UNITED STATES PATENT AND TRADEMARK OFFICE

10/501,821

| Office Action Summary | Application No. 10/501,821 | Applicant(s) HEATHCOTE ET AL. | |

DETAILED ACTION

Figure i- Okubo et al.'s figure.

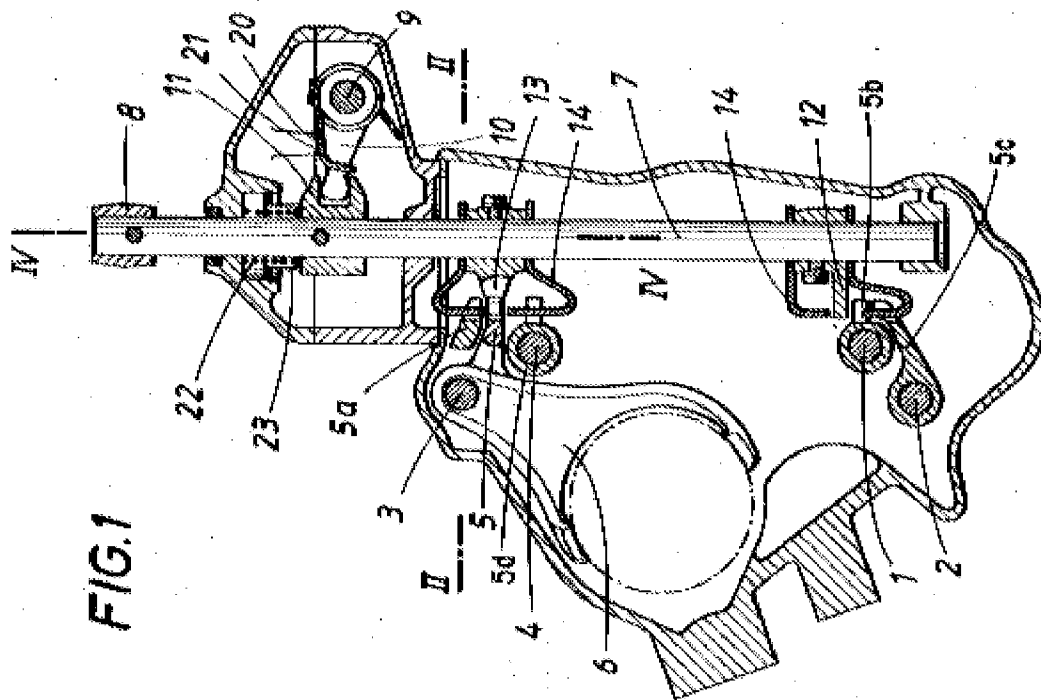
- A shift rail selector element comprising two tongues where the tongues are spaced apart a fixed distance. This corresponds to Okubo et al.'s shift fingers (fig.1, 12 and 13).
- A first and second shift rails which are connected to shift forks and both having interlocking elements. This corresponds to Okubo et al.'s shift rails (fig.1, 1 and 3), connected to shift forks (fig.1, 6) and (fig.2, 6'), and also having connecting members (fig.1, 5b, and 5).

Applicant claims a third shift rail connected to another shift fork and having an interlocking element, which corresponds to the shift rail (fig.1, 4) and shift fork (fig.3, 6a) and connecting member (fig.1, 5d).

Applicant claims the gear shifting mechanism having two groups of shift rails where each group has two shift rails which corresponds to the two groups (fig.1, 1 and 2) and (fig.1, 3 and 4) presented by Okubo et al.

Applicant claims that the distance between the tongues are greater than the distance between two adjacent interlocking member which Okubo et al. teaches as depicted in figure 1. The distance between shift rails 1 and 2 is less than the distance between tongues 12 and 13.

Applicant claims that the distance between the selector tongues is smaller than the distance between two spaced apart interlocking elements which corresponds to the relationship of distances between the tongues and connecting members 5a and 5c disclosed in Okubo et al. figure 1.

Applicant claims that all the interlocking elements have a width which is less than the width of the respective shift rail measured in the same directions. Okubo et al. teaches this through figure 1, where as seen the width of the connecting members is less than the width of rails.

Applicant claims that the width of the interlocking elements is approximately half the width of the respective shift rail measured in the same direction. This is also depicted in figure 1 of Okubo et al. in particular where connecting member 5b is approximately half the width of rail 1.

Applicant claims that the width of the tongues essentially correspond to the width of the interlocking elements which corresponds figure 1 of Okubo et al. where the width of the tongues (fig.1, 12 and 13) essentially correspond to the width of the connecting members 5, 5a-d).

Applicant claims the selector element having a blocking element which blocks the shift rails when the tongues are at least in partial engagement with the shift rails. This corresponds to what is blocking members (fig.1, 14 and 14') which

Figure iv- Meyers et al. figure.

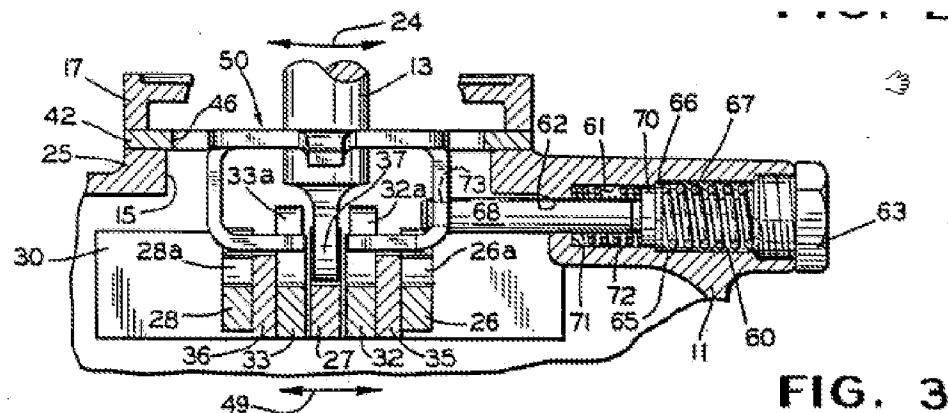
A gear shifting mechanism (fig.2, 12) for a transmission that has a blocking element (fig.4, 56) arranged a support (fig.4, 50) which can be displaced in a first direction (col.5, lines 46-51) allowing the engagement of various shift

The selector element (fig.3, 37) is biased towards a neutral center position by at least one spring (fig.3, 72 and 67) in the first direction. The selector tongue (fig.3, 37) engages a selected shift rail (fig.3, 27) through the connecting element (27a).

The support discussed above has an extension or shaft (fig. 3, 68) which supports a spring (fig.3, 67 and 72) which is supported between the driver plates (fig.3, 71 and 66), and stretched between detents (fig.3, 70) formed on the shaft and where two stationary contact faces (fig.3, 70 and 71).

Meyers et al. teaches the selector element as discussed above seated in the support (fig.3) which is seated in a housing or casing (fig.3, 11 and 17) and where the selector element has a means (fig. 3, 22) or a pin inside a dome which connects the selector element to a shift finger or lever (fig.3, 13).
